Record of Decision
Former Paulsen-Holbrook Site
State Superfund Project
Town of Guilderland, Albany County, New York
Site Number 401046

March 2010

This responsiveness summary responds to all questions and comments raised during the public comment period. The following are the comments received, with the Department's responses:

FIGURE 5A

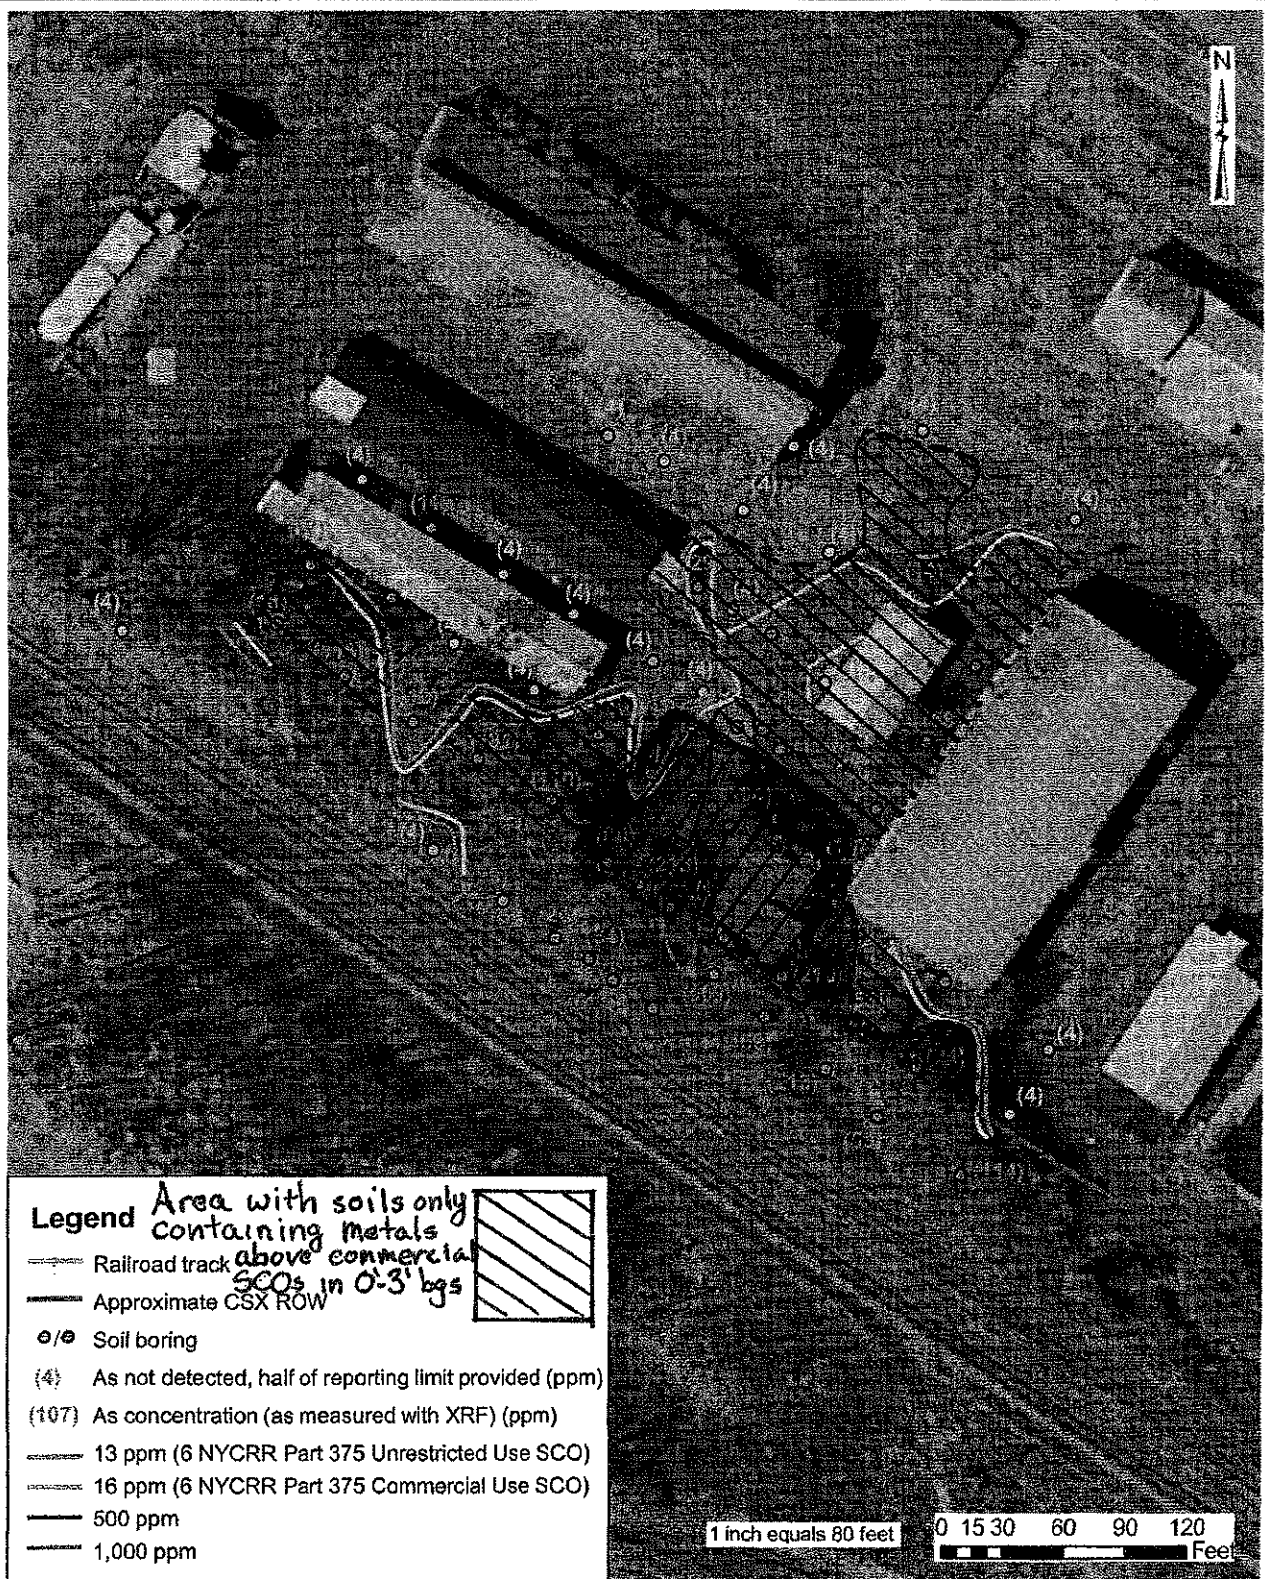
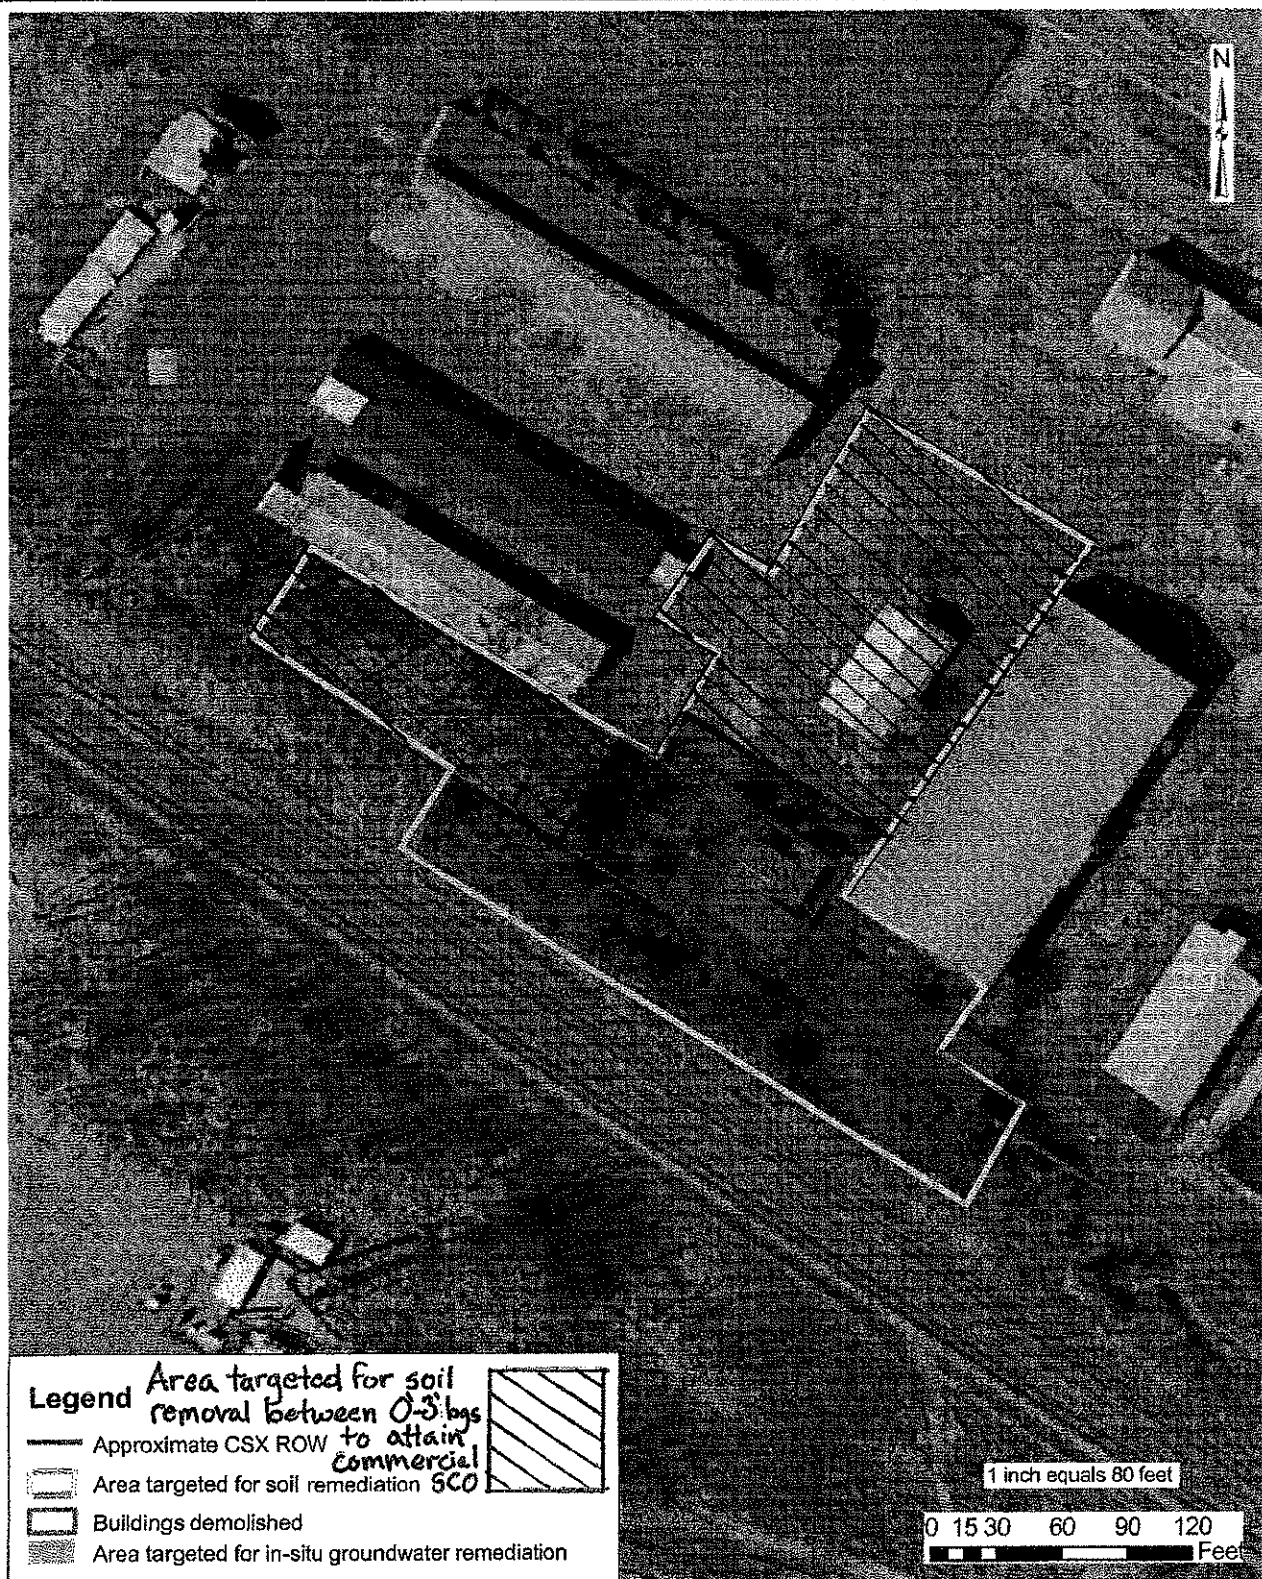
COMMENT 5: My client's goal is to maximize the utility of the property post-cleanup as quickly as possible. Therefore, my client requests that NYSDEC remove all of the contaminated near-surface soils found between 0' to 3' below ground surface outside of the hot zone.

My client estimates that an additional 3,800 square feet of property could be returned to productive use if NYSDEC would commit to excavating approximately an additional 140 cubic yards of contaminated soil from the highlighted areas [outside of the immediate vicinity of the former containment building as outlined on a figure provided by the letter writer]. Even if this work cost the NYSDEC \$100 per cubic yard, this would amount to only an additional \$14,000 of remedial costs in a \$1,980,000 project. For a mere 0.7% of the cost of the remedy, the remedy would cleanup significantly more of the site which could be utilized in the future without having to worry about disturbing solidified stabilized contaminants.

I am enclosing Figures 5A and 7 from the PRAP. These figures indicate that the area outside of the area around the former CCA treatment building has only shallow (0'-3' bgs) subsurface contamination, all of which can be cost-effectively removed. According to the proposed remedy, NYSDEC is already committing to remove the top twelve (12) inches. The remaining contaminated soils from 1' to 3' bgs in the highlighted area can be removed at the same time.

RESPONSE 5: A quick examination of the areas in question shows that the actual square footage affected by the letter writer's proposal is about 30,000 square feet. Approximately 1,110 cubic yards (cy) of contaminated soil would be removed from the 0-1 foot interval. An additional 870 cy would need to be removed from the 1-2 foot interval and 250 cy from the 2-3 foot interval under the letter writer's proposal. The estimated cost to excavate, remove, and properly dispose of the additional 1,120 cy of contaminated soil from the 1-3 foot interval is as follows: \$6/cy for excavation and \$125/ ton for loading, transport, and disposal of contaminated soil as non-hazardous waste. Using a conversion factor of 1.6 tons/cy of soil yields an added cost of approximately \$230,000, or a 12% increase in the cost of the remedy. If the additional soil were disposed as hazardous waste at \$225/ton, the \$410,000 cost would represent a 21% increase in the cost of the remedy.
